TVA-WBN-TS-98-011

WATTS BAR NUCLEAR PLANT (WBN) UNIT 1 - REQUEST FOR TECHNICAL  
SPECIFICATION (TS) AMENDMENT FOR TS 3.6.8 - HYDROGEN MITIGATION  
SYSTEM (HMS) (TS 98-011)

### PROPOSED LICENSE AMENDMENT HYDROGEN MITIGATION SYSTEM

IGNITER LOCATIONS -  
LOWER COMPARTMENTS  
FIGURE 6.2.5A-2

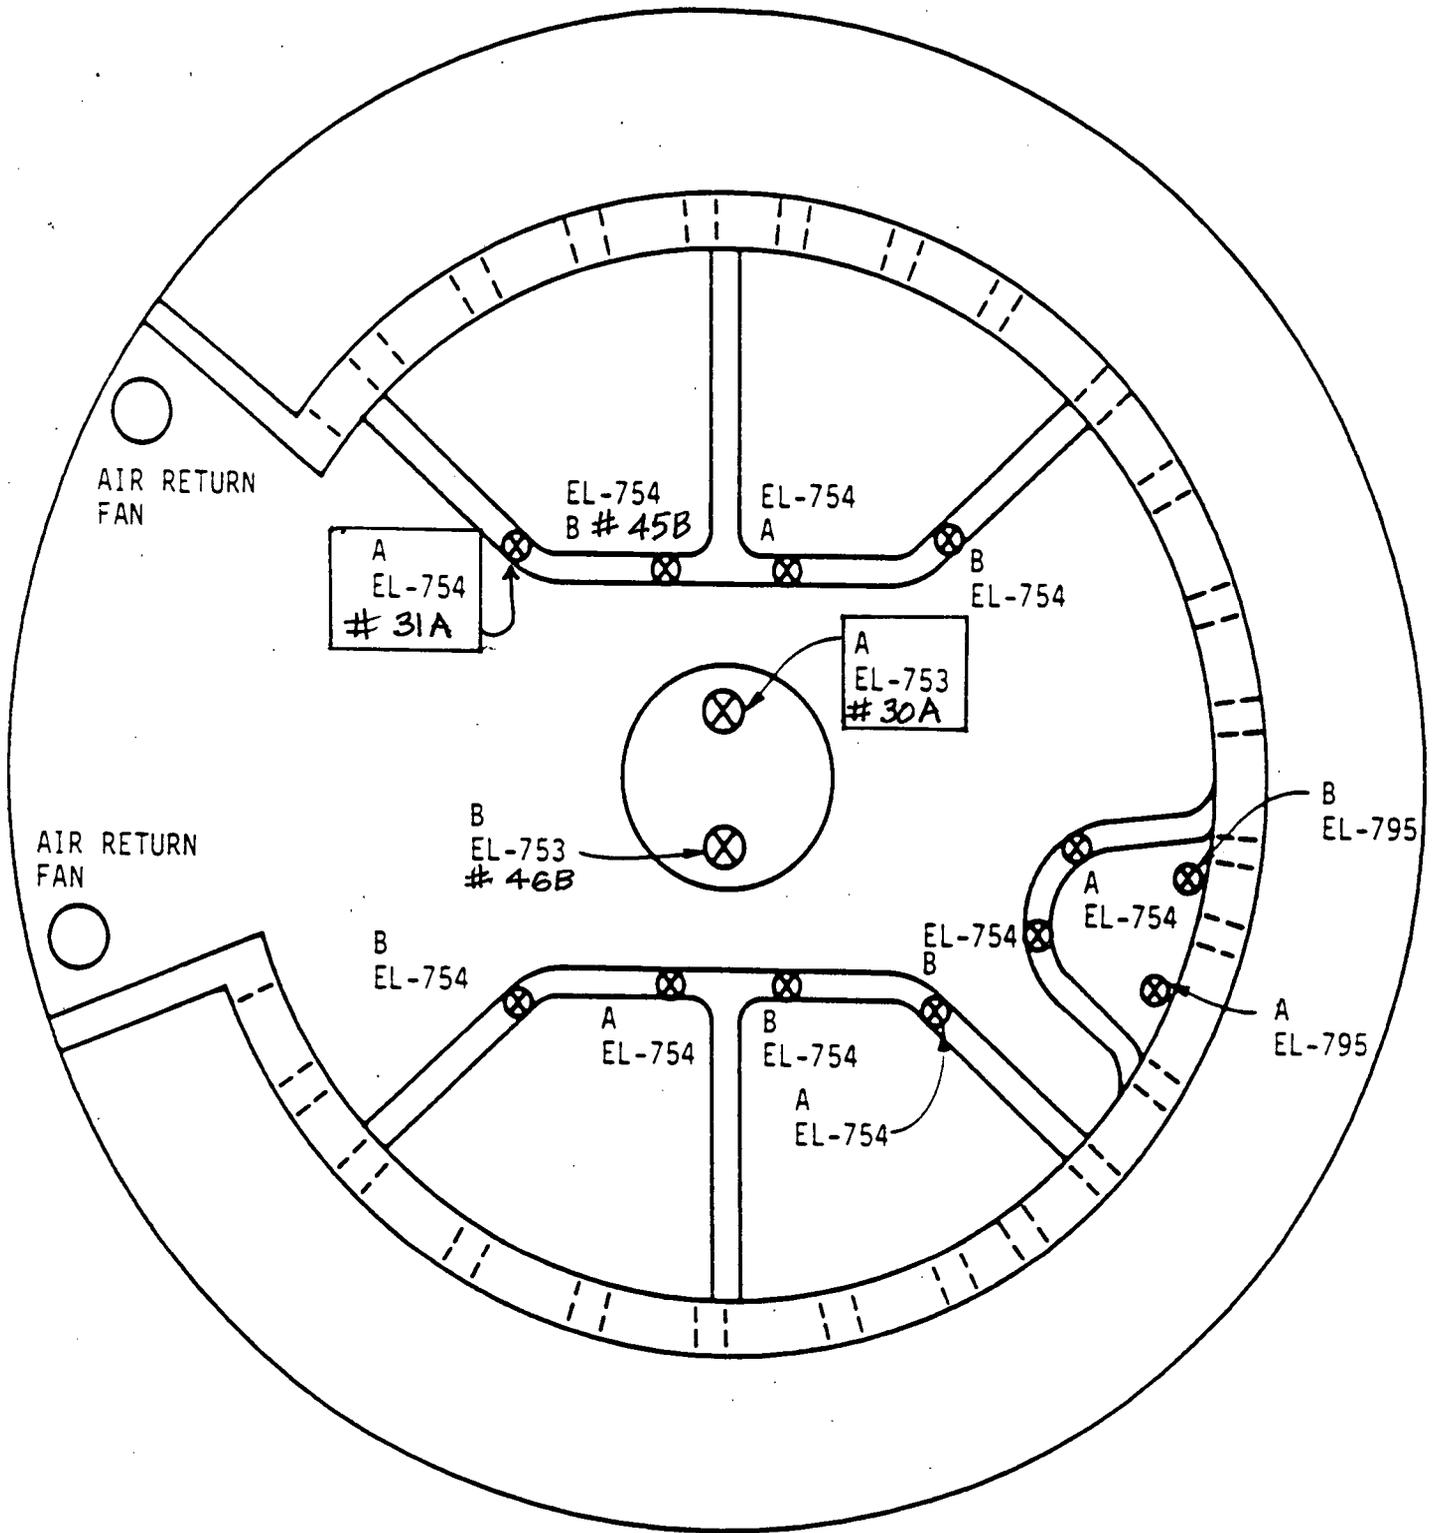
On April 3, 1998, at 0130 hours, TVA entered TS 3.6.8, Condition A (one HMS train inoperable) due to the failure of two hydrogen ignitors to energize during the surveillance testing required by Technical Specification Surveillance Requirement (SR) 3.6.8.1. Both ignitors are located in separate areas of lower containment and are fed by the same common circuit which has an apparent fault. These ignitors are located in very high radiation and temperature areas that presents a concern for personnel safety to perform repairs while at power; therefore, repairs cannot be made until the reactor is taken offline to allow access to that area. Although the HMS would be capable of adequately performing its intended design function under the existing conditions, a failure of Train B emergency power during required monthly testing of the EDGs, if not restored within 4 hours, (or a loss of normal Train B power) would require a plant shutdown with no corresponding benefit to the public health and safety. The proposed temporary change to the TS addresses this issue. The attached annotated Updated Final Safety Analysis Report (UFSAR) Figure 6.2.5A-2 illustrates the location of the inoperable ignitors.

There are at least two ignitors, controlled and powered redundantly, located in each of these regions. Spray shields provide protection from the containment spray system on those ignitors exposed to the spray. The HMS is currently considered operational if upon completion of required tests, there are 33 of 34 ignitors operating in each train provided that the failed ignitors do not render a containment region inoperable. Currently, HMS Train A has 2 of 34 ignitors that are not functional. HMS Train A has been declared inoperable by definition. As required by LCO 3.6.8, ACTION A.1, plant operation may continue provided that WBN tests the OPERABLE train ignitors once per seven days until the inoperable train is restored to operable status. Ignitor 31A is located on Elevation 754 above reactor coolant pump 4 at the lower edge of the steam generator No. 4 enclosure and ignitor 30A is located on Elevation 753 above the reactor vessel in the reactor cavity.

Under the proposed TS change, HMS Train A would be considered OPERABLE with the two specific ignitors (30A and 31A) out of service, provided the remaining 32 of 34 ignitors continue to be OPERABLE. These 32 Train A ignitors are currently OPERABLE and would adequately accomplish the intended design function of the HMS during the highly unlikely event of a degraded core accident. During a loss of Train B power, the proposed TS would permit the reactor cavity and SG No. 4 lower compartment enclosure regions to have no OPERABLE ignitors for a very limited duration of 72 hours during which time power must be restored or a plant shutdown to MODE 3 achieved within the following 6 hours. The cause of failure for the two Train A ignitors is considered isolated to their circuitry due to an apparent fault in wiring common to those ignitors. However, because HMS Train A is experiencing non-optimum conditions, increased surveillance testing in accordance with SR 3.6.8.1 will be performed for HMS Train A with an increased frequency of 46 days instead of the currently required 92 days.
